ADDENDUM No. 2 – (March 9, 2020)

ADDENDUM TO: LED Sports Lighting, RJS
BID NUMBER: Bid #19-04
BID DUE DATE: Tuesday, March 17, 2020 not later than 10:00am

LED SPORTS LIGHTING

Bid# 19-04

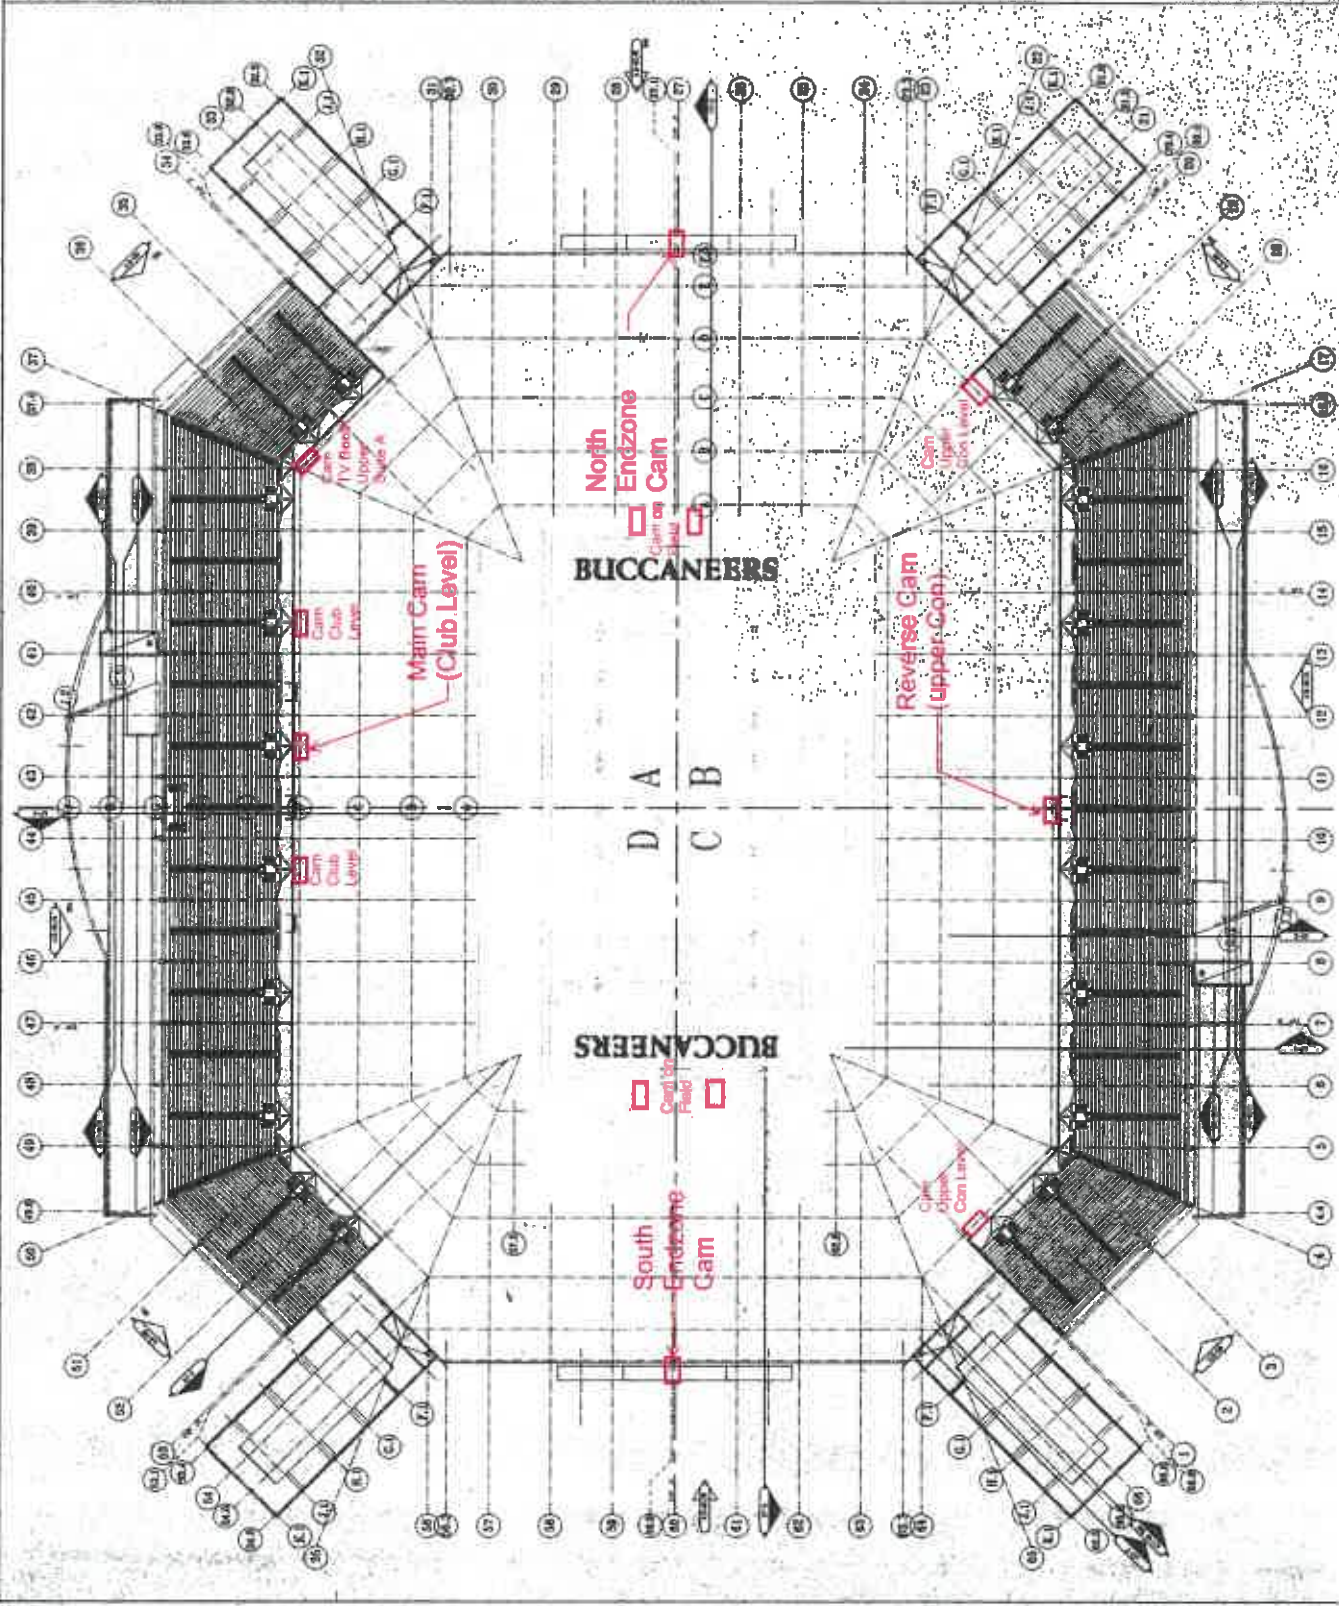
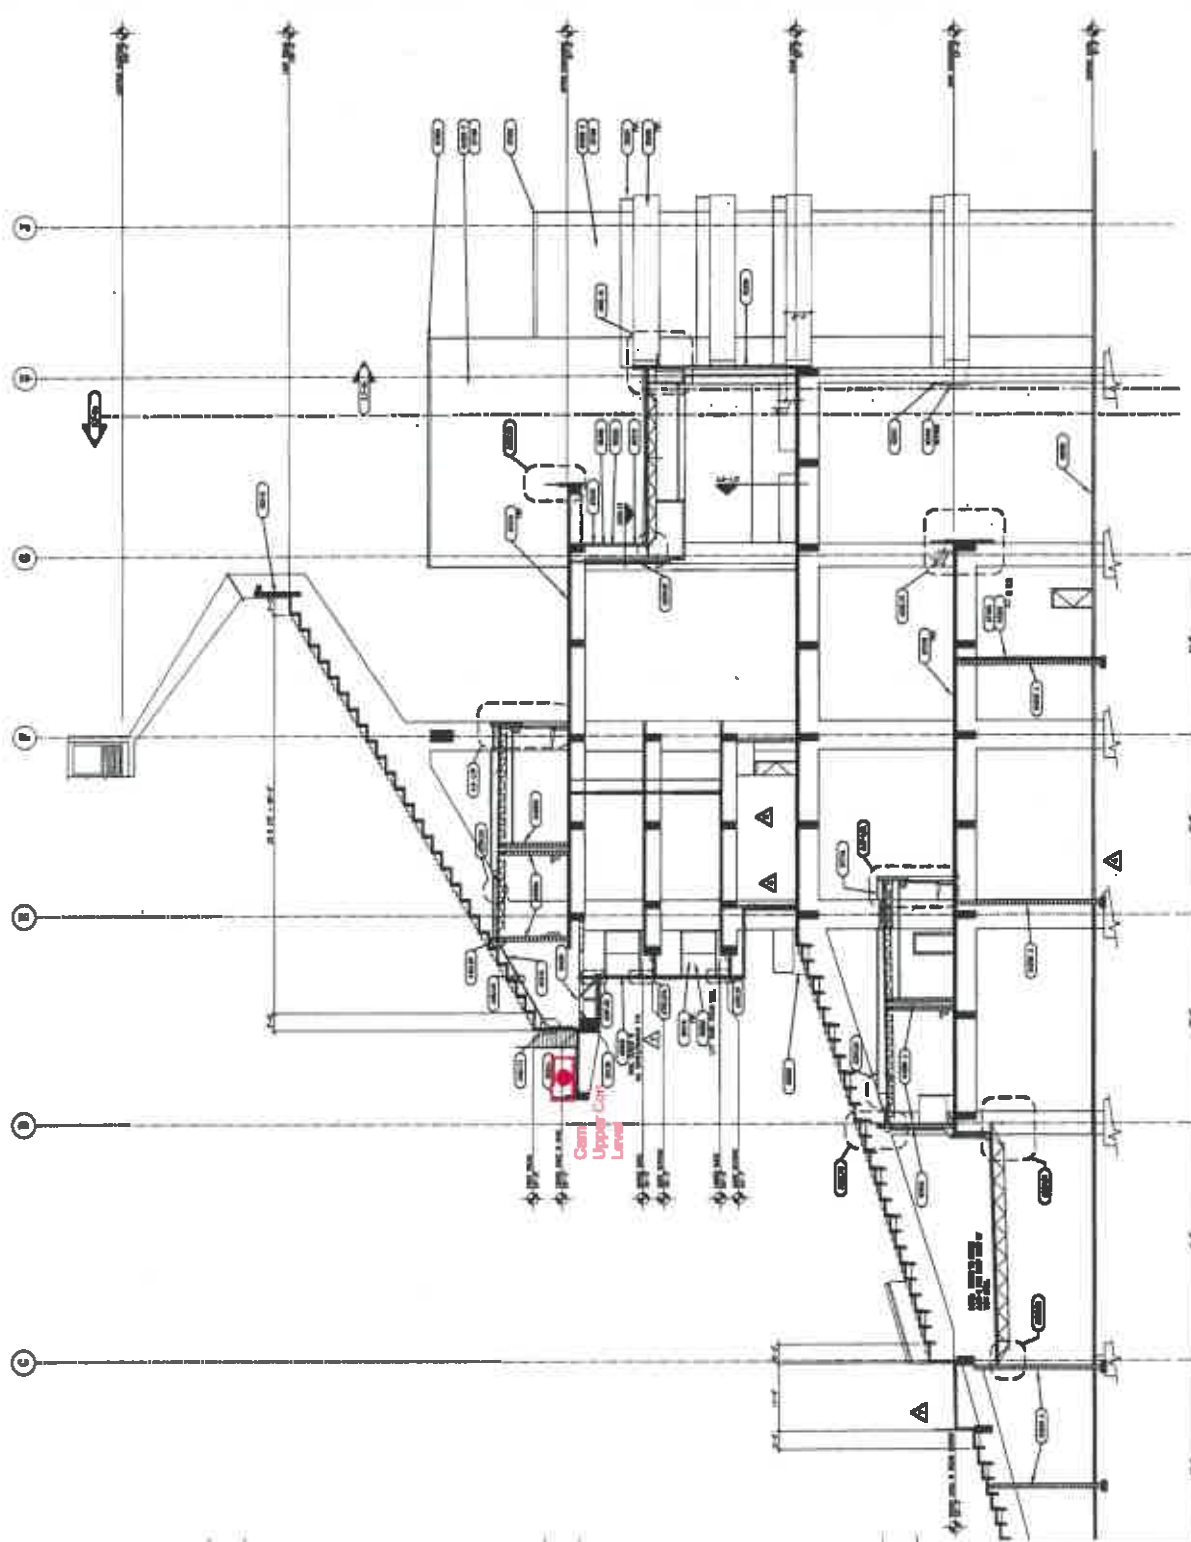
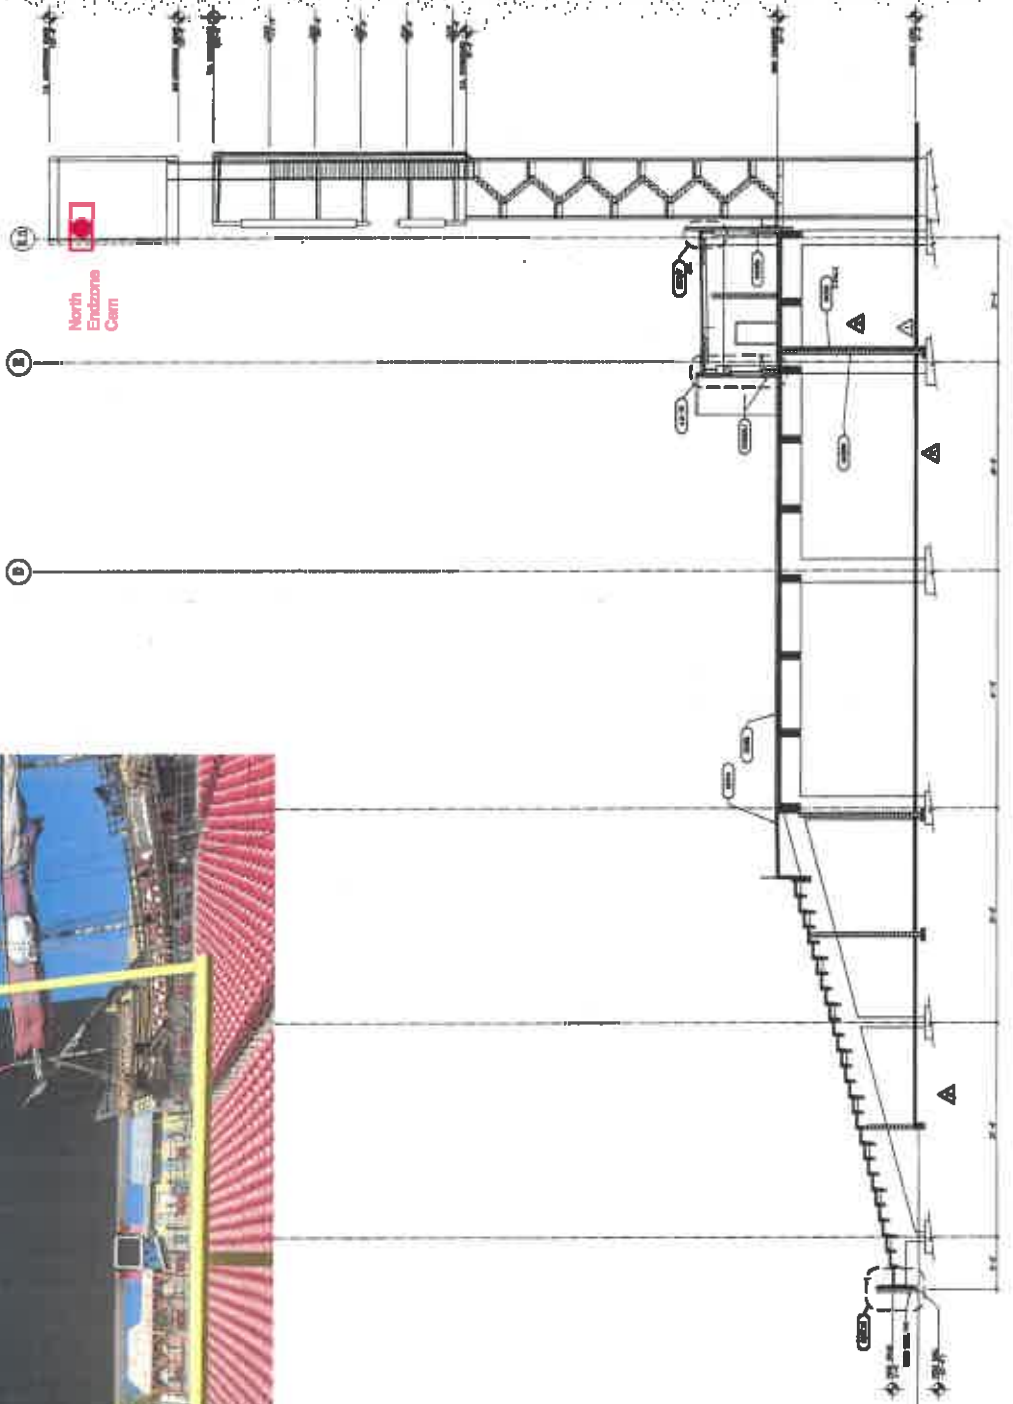
3. Please provide drawings that define elevations for the seating. Sections/elevations of the seating bowl. **Refer to attached drawings identified as Exhibit "B".**

4. Please provide drawings that define the (x,y,z) coordinate of each camera location. (Main/Reverse/both End Camera's). **Refer to attached drawings identified as Exhibit "B".**

- Lower Bowl 3-foot candles
 - Upper Bowl 3-foot candles
6. What are the camera heights in the stadium? Refer to attached drawings identified as Exhibit "B".
